**ALERT SERVICE BULLETIN**

NO. 212-10-140

**MODEL AFFECTED:** 212

**SUBJECT:** HIGH FORWARD CROSSTUBES, P/N 205-050-403-031, 412-050-046-101, MANDATORY INSPECTION

Figure 1

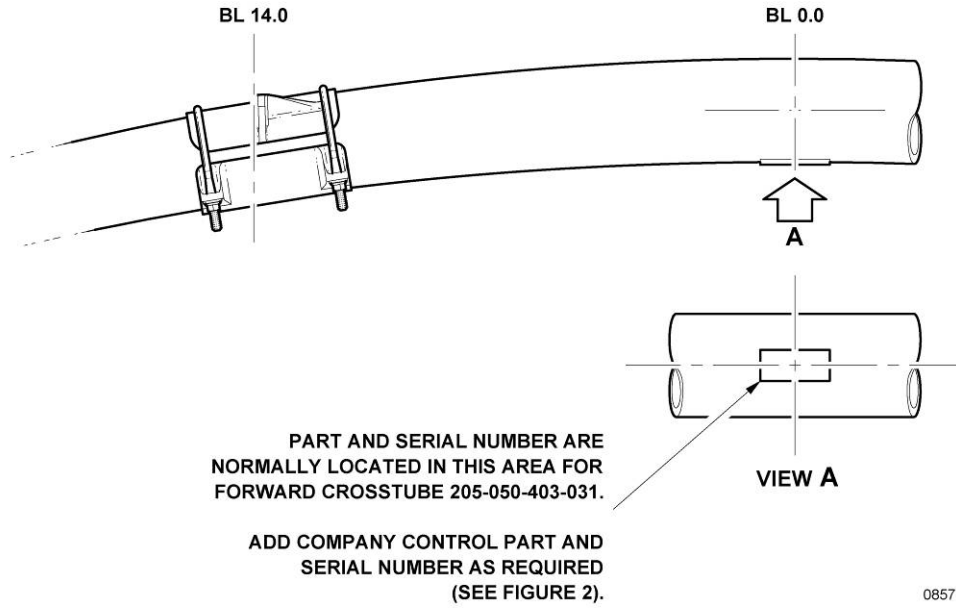
High forward crosstubes assemblies P/N 205-050-403-031 are identified by the use of a decal at BL 0.0 lower side, see Figure 1. If this decal is no longer legible or is missing, determine crosstube part number using helicopters records.

Figure 2

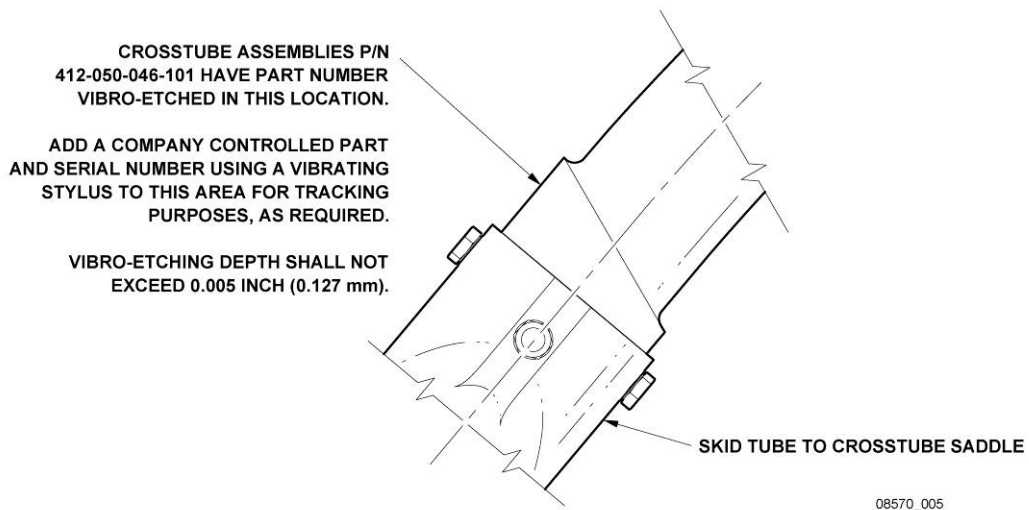
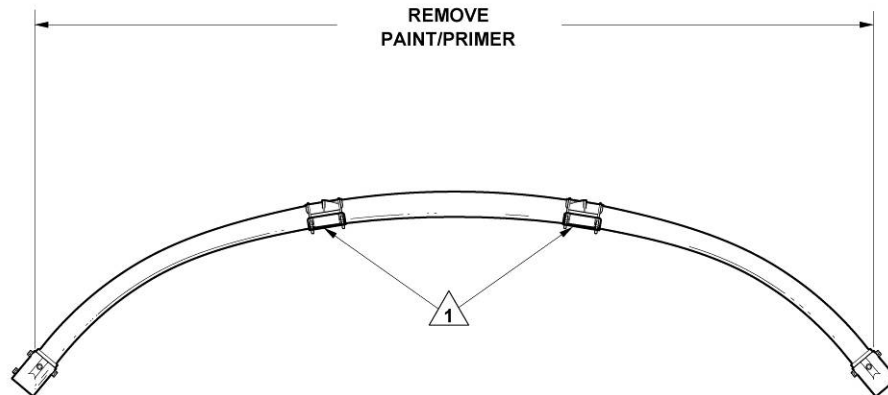
High forward crosstubes assemblies P/N 412-050-046-101 have a part number that is vibro-etched on the crosstube adjacent to the skid tube saddle as indicated in Figure 2.

3. Bell Helicopter Textron crosstubes not clearly displaying a visible part and serial number are required to be identified. The part and serial numbers are to be vibro-etched on the crosstube adjacent to the skid tube saddle as indicated in Figure 2. Vibro-etching depth of this information shall not exceed 0.005 inch and shall be accomplished as indicated.

A) Crosstubes using a two piece saddle arrangement (P/Ns 205-050-132-001, 205-050-133-001) are to indicate P/N 205-050-403-031FM and a company controlled serial number.

B) Crosstubes using the single upper saddle ( P/N 412-050-038-101) that is riveted to the crosstube and a lower composite film abrasion strip (206-050-301-109) shall indicate P/N 412-050-046-101FM and a company controlled serial number.

**Figure 3**

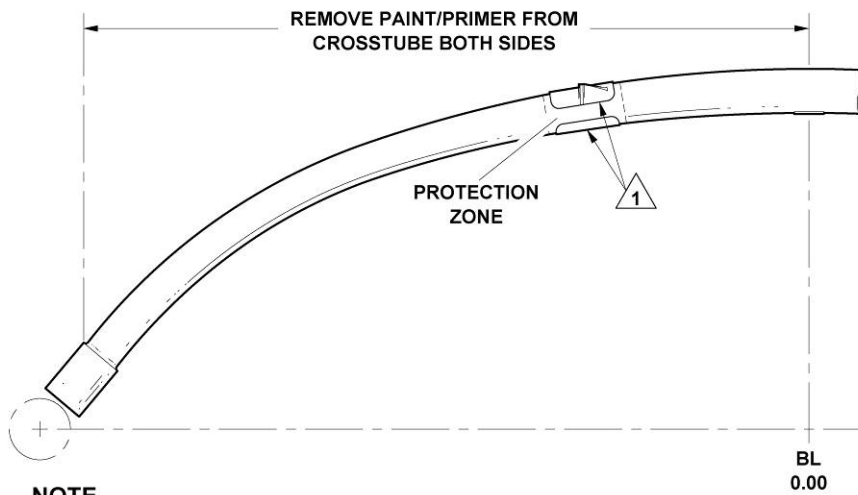
2. Prepare crosstube for the inspection process by removing paint on the crosstube.
  - a. Crosstube P/N 205-050-403-031 will require the exterior paint to be completely removed as indicated in Figure 3. The supports P/N 205-050-132-001 and 205-050-133-001 are removed for this step, as previously indicated.
  - b. Crosstube P/N 412-050-046-101 will require the exterior paint to be removed with the exception of the BL 14 area at the upper supports and lower abrasion strips, which are to be protected as indicated in Figure 4.
3. Apply chemical paint remover (C-436) to the crosstube with a brush following manufacturer's directions and the BHT-ALL-SPM.

1 Supports P/N 205-050-132-001 (upper) and 205-050-133-001 (lower) are removed prior to paint removal.
